**DOCUMENT 00 91 04
ADDENDUM NO. 4**

PROJECT: 2024 Cy Lakes HS Renovation
BID DATE: **Thursday, December 19, 2024 (no Change)**
FROM: Carolina Weitzman, A.I.A.
Natex Corporation Architects
447 Heights Blvd, Houston, TX 77007
TO: **Prospective Bidders**

**2024 CY-LAKES HIGH SCHOOL
RENOVATION**
5750 GREENHOUSE RD., KATY, TX 77449
CFISD PROJECT NO. 24-02-5749-R-RFP

1 Auditorium Audio System Schematics
 Scale: None

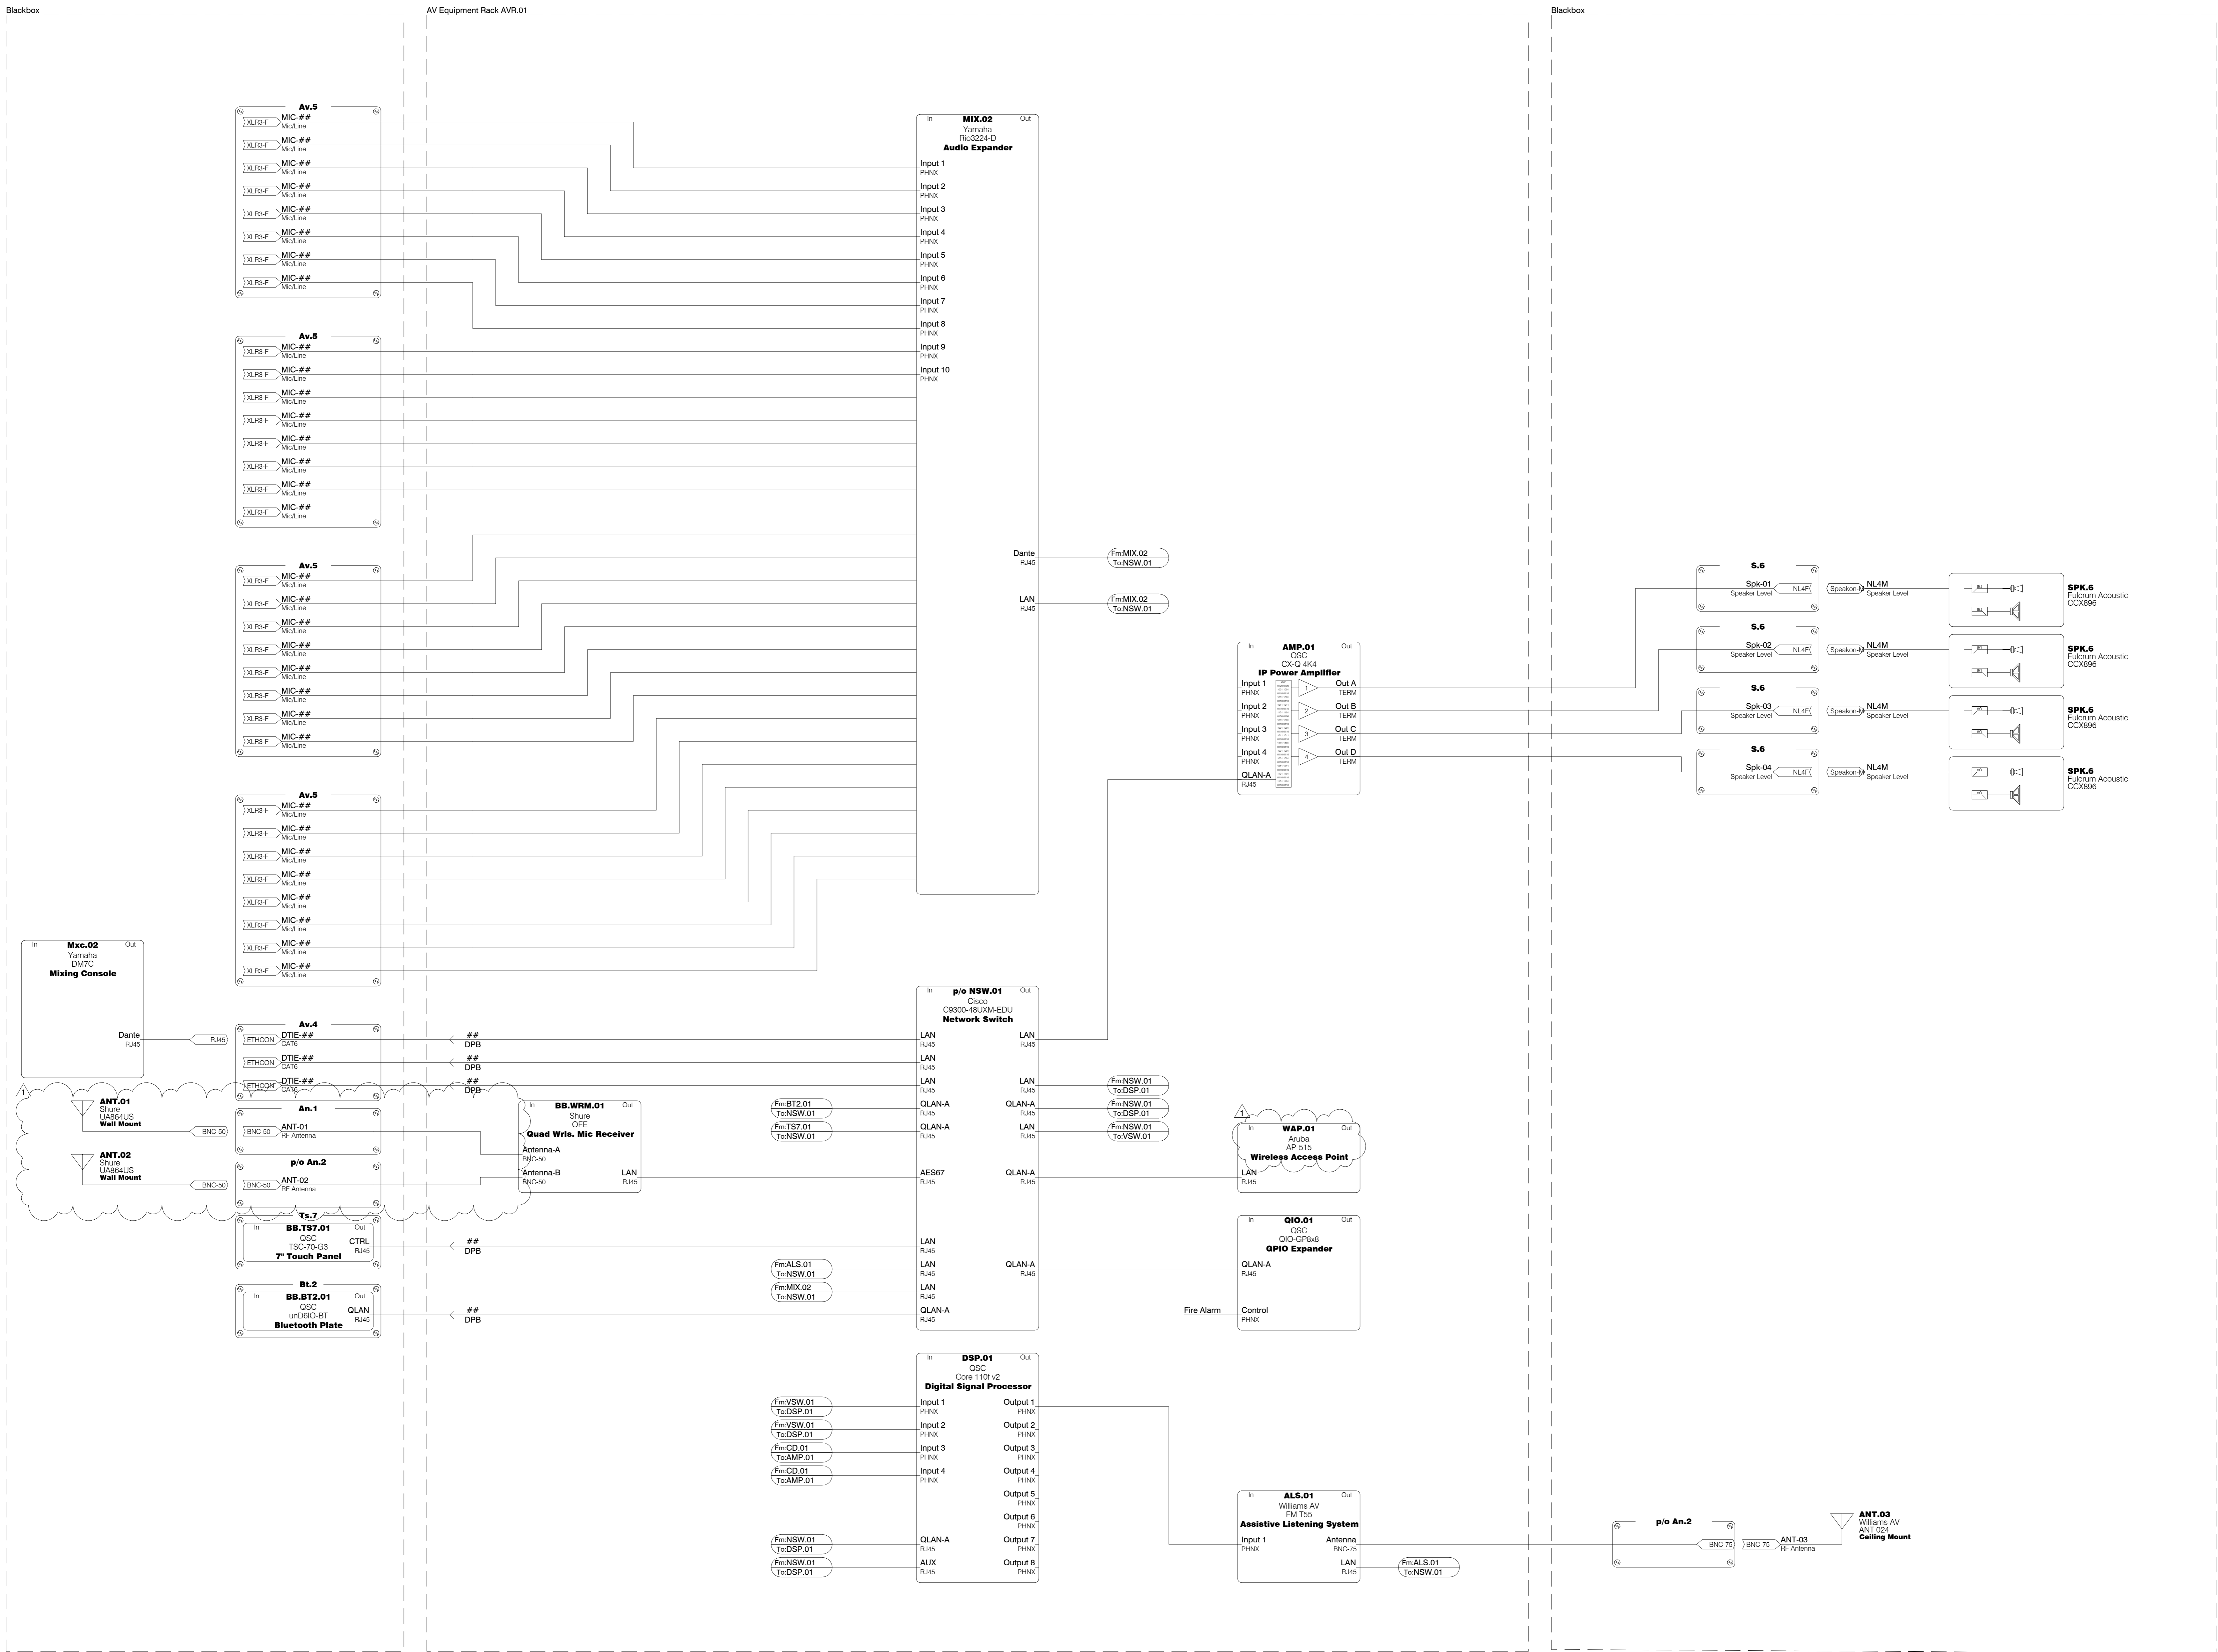
5. AV7.31 – AV SCHEMATICS
 - a. Change wireless access point to Aruba AP-515
 - b. Change projector screen to Draper 101782
 - c. Refer to revised sheet

6. AV7.33 – AV SCHEMATICS
 - a. Change wireless access point to Aruba AP-515
 - b. Showed wireless microphone antenna plates.
 - c. Refer to revised sheet.

3. **Question:** Auditorium Screen ModelAV series drawing AV7.31 details a Draper 144006 projection screen to be installed in the auditorium. Specification Section 274134-33 & drawing AV0.002 details a Draper 101782 screen to be installed into the auditorium. Please confirm which model screen to is to be installed in the auditorium.
Answer: Updated in Add 4. Draper 101782.

4. **Question:** Blackbox DSP Model - AV series drawing AV7.33 details a QSC Core 110f-v2 to be installed into the blackbox rack. Specification Section 274134-34 details a QSC Core 8 Flex to be installed into the blackbox. Please confirm which model dsp is to be installed in the blackbox.
Answer: Clarified in Add. 4 - QSC Core 110f-v2.

6. **Question:** Wireless Access Point - AV specifications 274134-31 & 274134-34 details an Aruba IAP-315-CI for the wireless access point for the auditorium and blackbox. This Aruba model has been discontinued by the manufacturer and on AV7.31 details a Netgear wireless access point to be used in the auditorium. Please provide a make and model of wireless access point to be used in the auditorium and blackbox.
Answer: Clarified in Add 4. Use Aruba AP-515.
